THE BOEING COMPANY  
AERO-SPACE DIVISION  
LETTER OF TRANSMITTAL AND SHIPMENT NOTICE

One (1) copy of revision to Source Control Drawing 10-81000 "Dyna-Soar Ejection Seat and Survival System" dated March 16, 1962 (Unclassified)

DRAWN	Joseph M. Bottem Bill S. Mill	DATE	6-1-61	DYNA-SOAR EJECTION SEAT AND SURVIVAL SYSTEM	BOEING AIRPLANE COMPANY AERO-SPACE DIVISION SEATTLE 24, WASHINGTON
CHECKED	C. L. Rehkopf	6-1-61			
STRESS CHK					
ENGR	Robert R. Miller Robert R. Miller	6-2-61			
GROUP APPROVED	for Glenda H. Graham	6-2-61	USED ON Dyna-Soar 1	10-81000	
PROJ APPROVED	R. A. Staggs		CODE	PAGE 1 OF 35

## DYNA-SOAR EJECTION SEAT AND SURVIVAL SYSTEM

SEAT AND SURVIVAL SYSTEM ENVELOPE

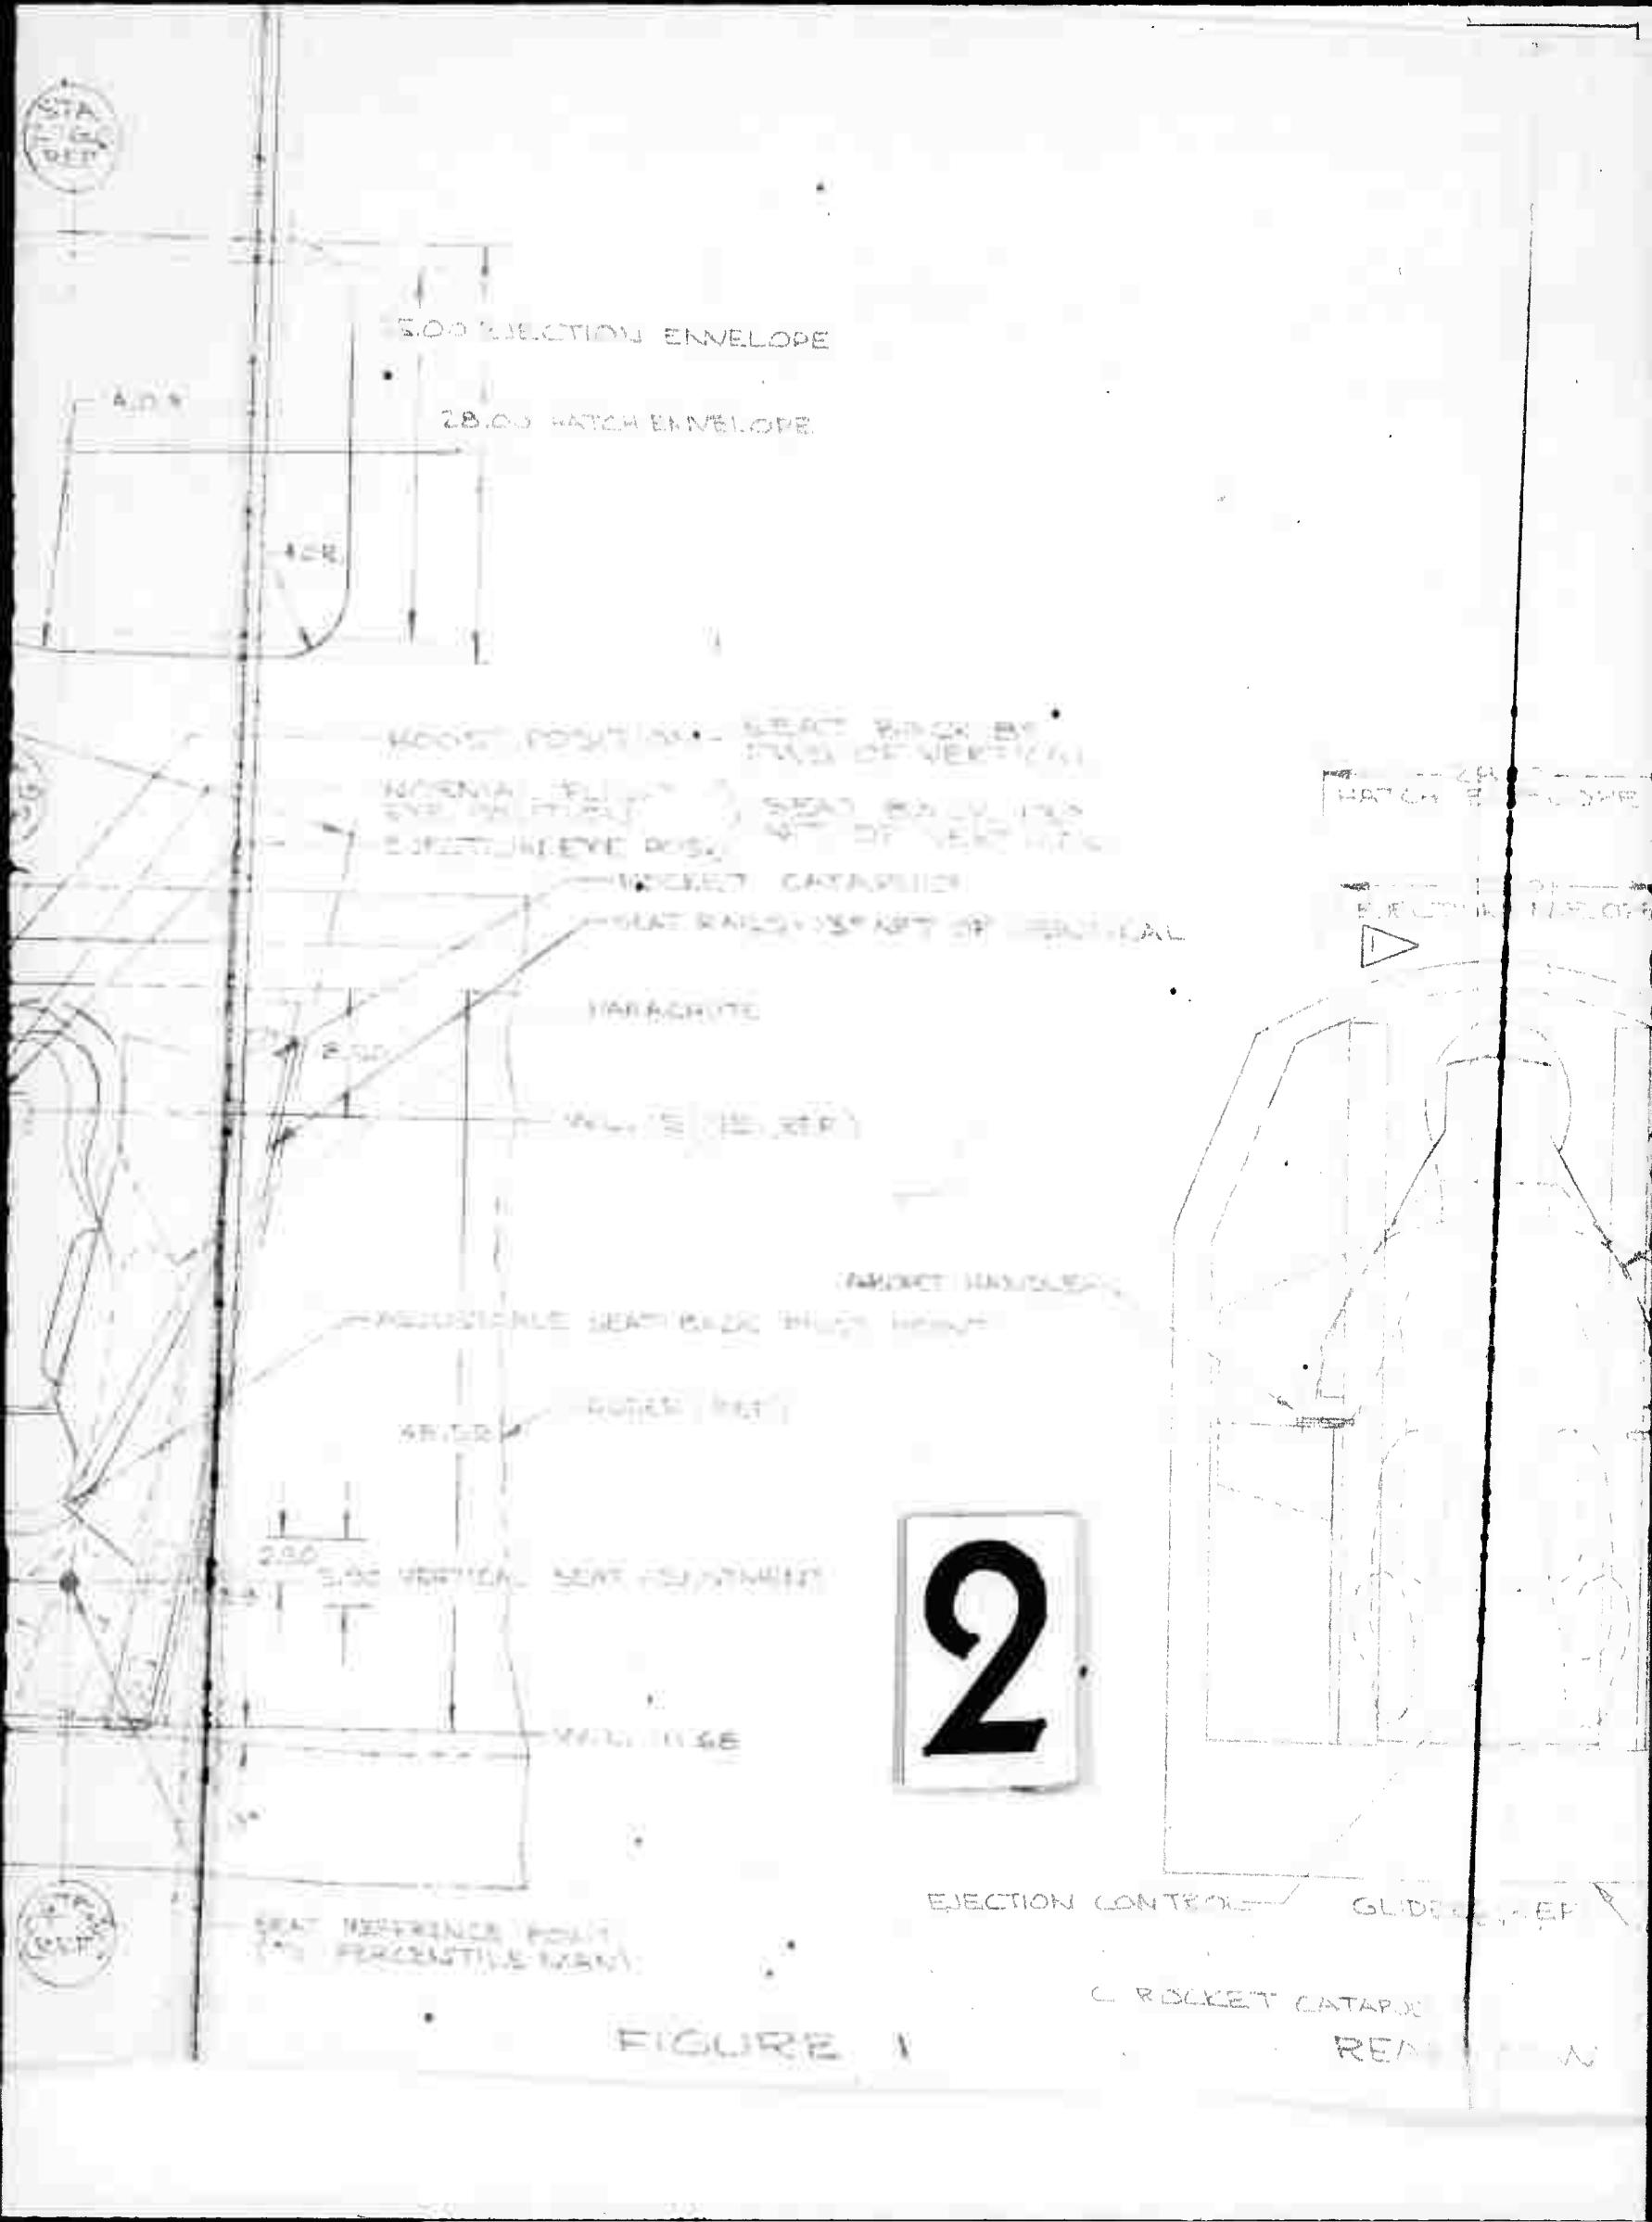
SYM	DESCRIPTION	DATE	APPROVAL
D	<p>(1) Changed seat back boost position angle from 3 degrees aft to 2 degrees forward and called for adjustable upper arm supports to conform. (2) Revised sled test requirements to call out specific responsibilities and requirements, including heat shield in Appendix B. (3) Made The Boeing Company responsible for the lower half of the tube-cutter electrical disconnect and the pressure switch tube disconnect. (4) Called out rail hole size and rail end chamfer. (5) Called for safety pin in harness release handle. (6) Clarified "D" ring position in Figure 8.</p> <p>Reason: (1) Customer requested new seat back angle for boost. (2) through (6) Completion of basic design and drawing clarification. BO-2-0046</p>	11/16/62	Phelps
		9-19-62	Bob 3/16/62
		10-81000

3.2.10.1 UPPER ARM SUPPORT. Contoured arm supports shall be provided on each side of the ejection seat back to provide maximum support to the upper arms of the pilot during boost. The arm supports must clear the hatch envelope; although they may exceed the nominal 25 inch ejection envelope, since the pilot's arms will not be in this position during ejection. See Figure 1, Page 22.

Deviation: The revised dimensional requirements are reflected in Figure 1, Page 22, of this drawing.
